Agenda Date:	June 27, 2019	Application ID:	SP 2019-06
Project:	Diversified Aviation Phase IIA	Project Number:	PRJ 2019-08
Project Planner:	Joseph Yaciuk, Planning Administrator		
Owner:	Cary Goldberg	Agent:	Barranco Gonzalez Architecture
Location:	North of Pembroke Road and west of Southwest 72 Avenue		
Existing Zoning:	A-1 (Limited Agricultural)* (Existing Airport)	Existing Land Use:	Transportation
Reference Applications:	SP 2011-18, ZV 2011-50, SP 2012-12, SP 2014-23		
Applicant Request:	Amending a previous site plan to allow for the construction of two new Hangars to replace three previously approved and unbuilt hangars.		
Staff Recommendation:	Approval, subject to the applicant providing LED lighting fixtures that do not exceed 3000k Correlated Color Temperature (CCT) in compliance with City of Pembroke Pines lighting code.		
Final:	<input checked="" type="checkbox"/> Planning & Zoning Board	<input type="checkbox"/> City Commission

Re: SP 2019-06 (Diversified Aviation)

PROJECT NAME: Diversified Aviation at NPA – Ph. IIA

PROJECT NAME: **Diversified Aviation at North Perry Airport –Phase IIA;**
SP2019-06

STANDARD ROAD DETAIL	FIRE LANE REQUIREMENTS															
Scale: NTS	Date: 05/13/19															
Job No.: 11-0968.06	Plot Date: 06/18/19															
Drawn by DRS	Sheet No. C5															
Proj. Mgr. DRS																
Appr. by DRS	5 of 5

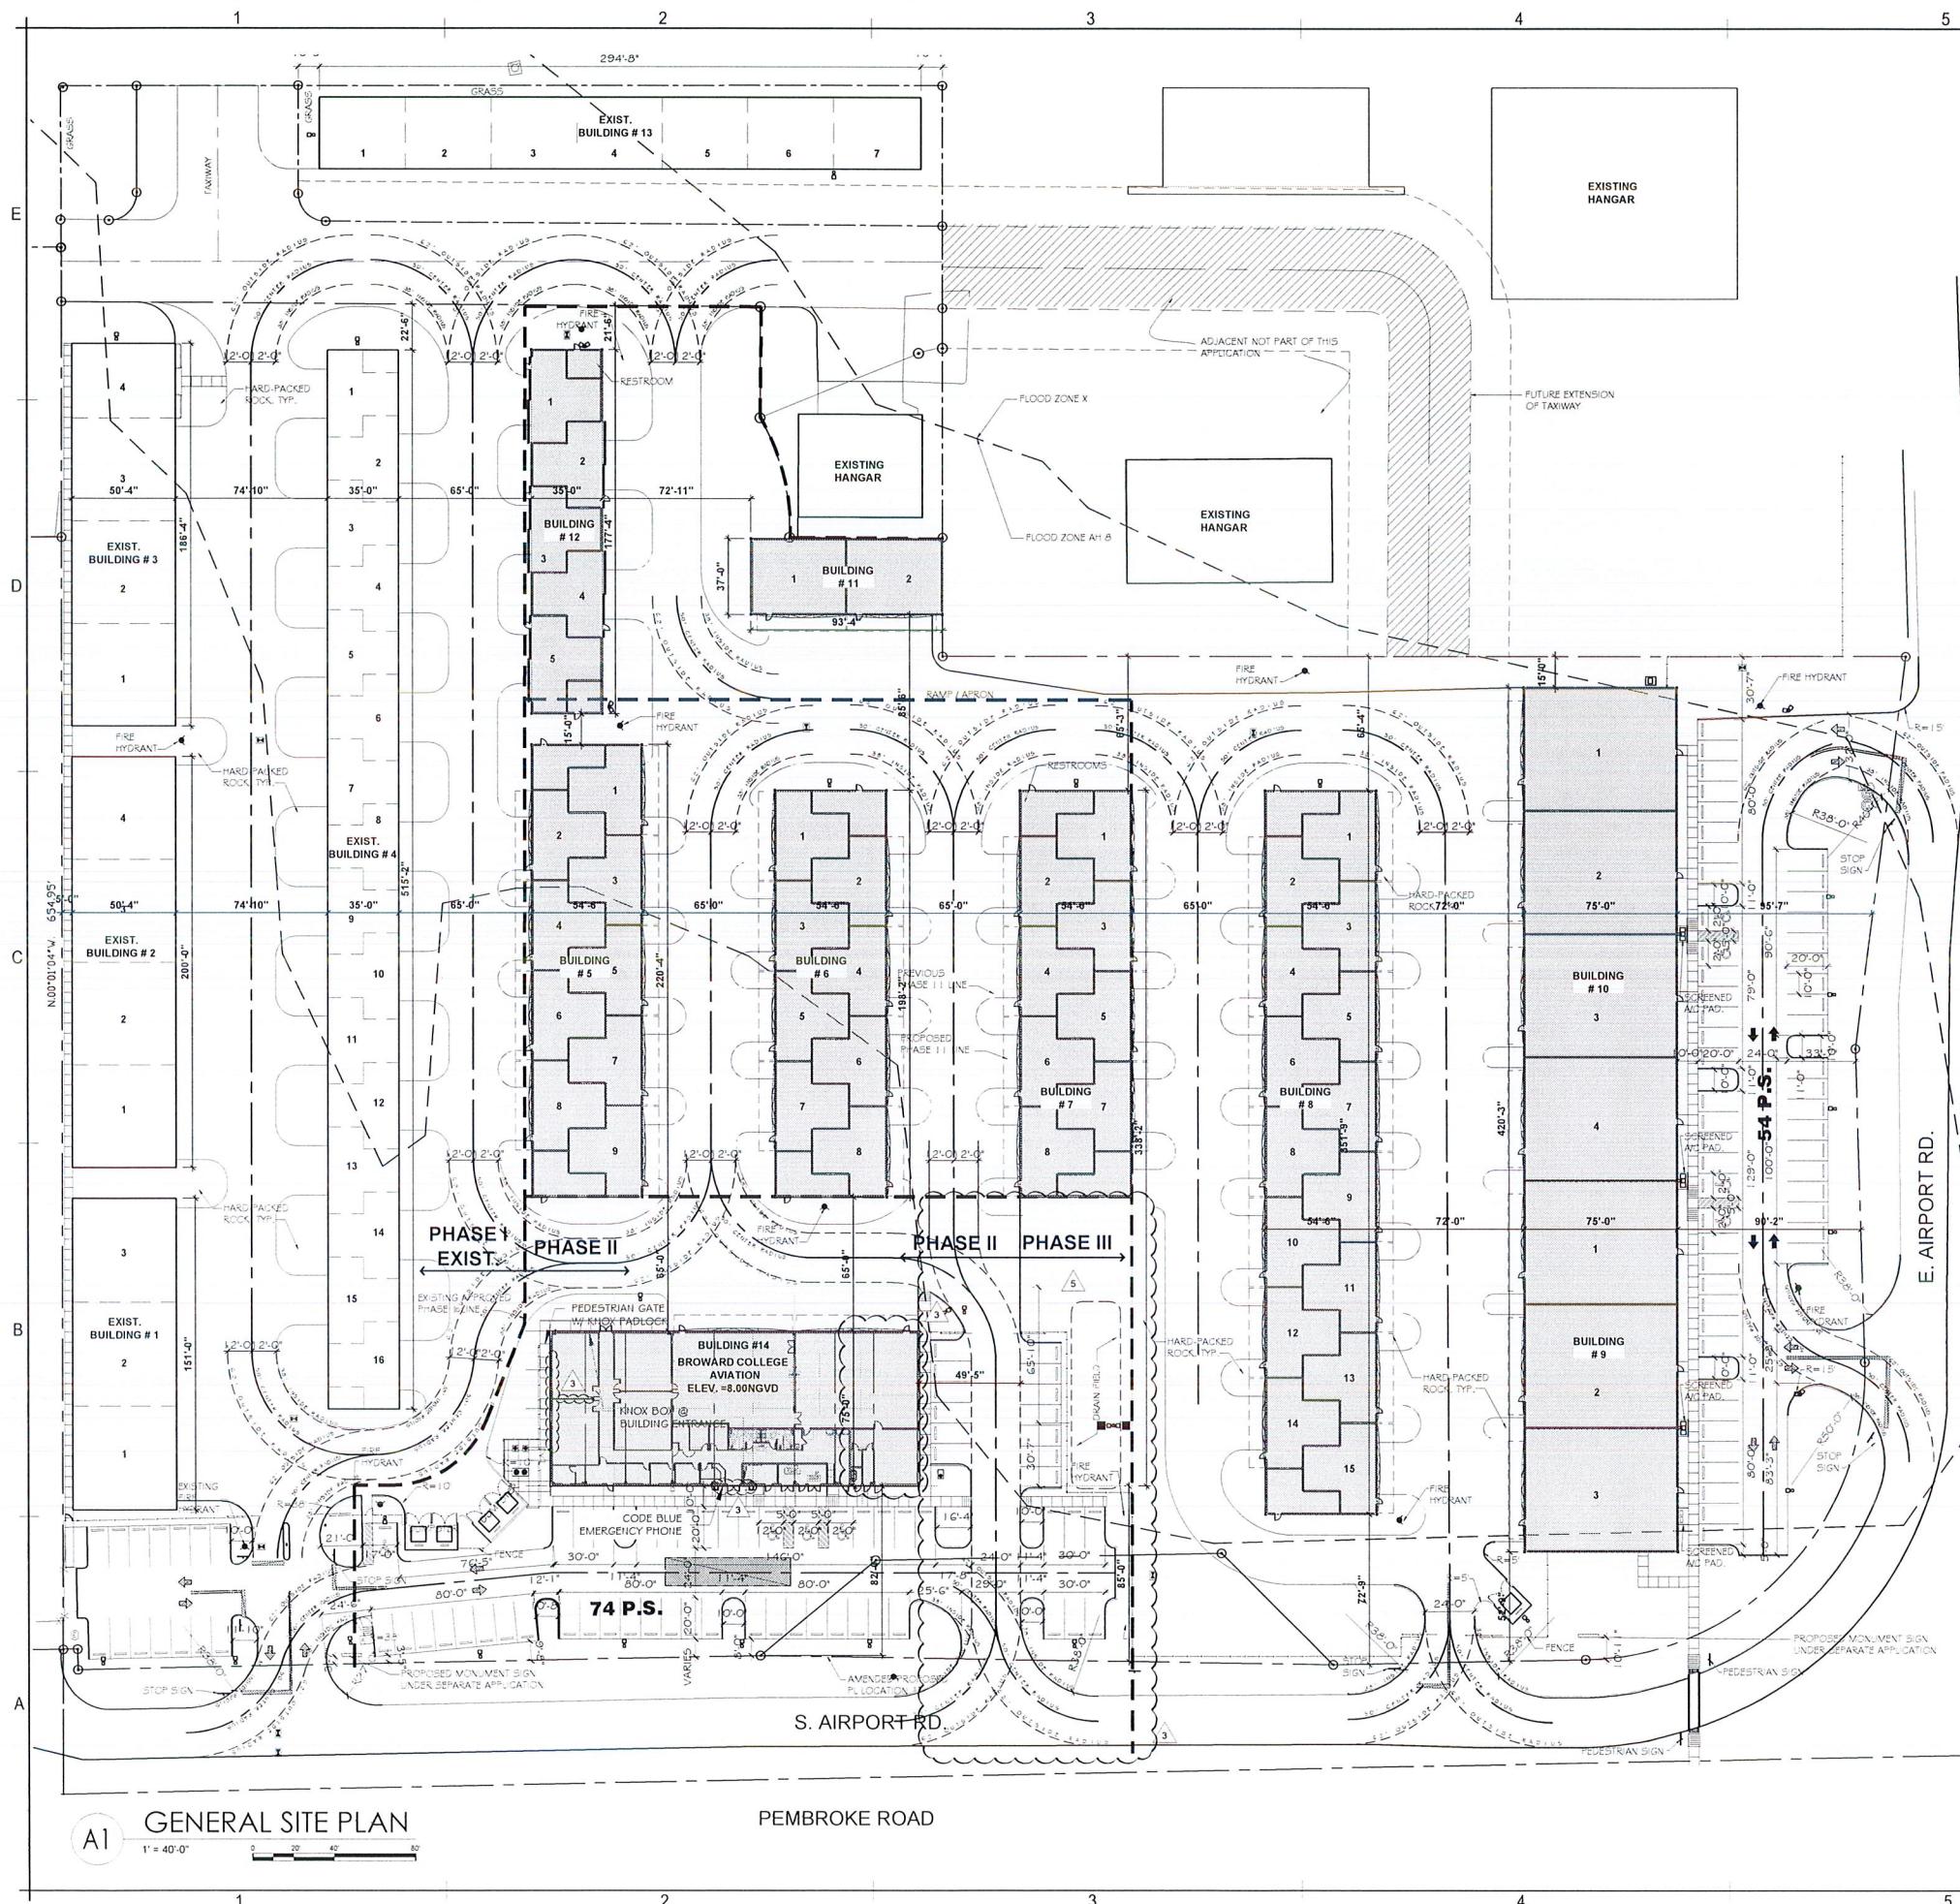
7. I am unclear if these buildings are to be provided with fire sprinkler systems. Page C5 has multiple references to fire sprinklers, fire department connections, and a DDCV detail, but yet Point of Service is not declared, and FDC & DDCV placement not shown. If a sprinkler system is not required in accordance with NFPA 409, please remove references or indicate not used.
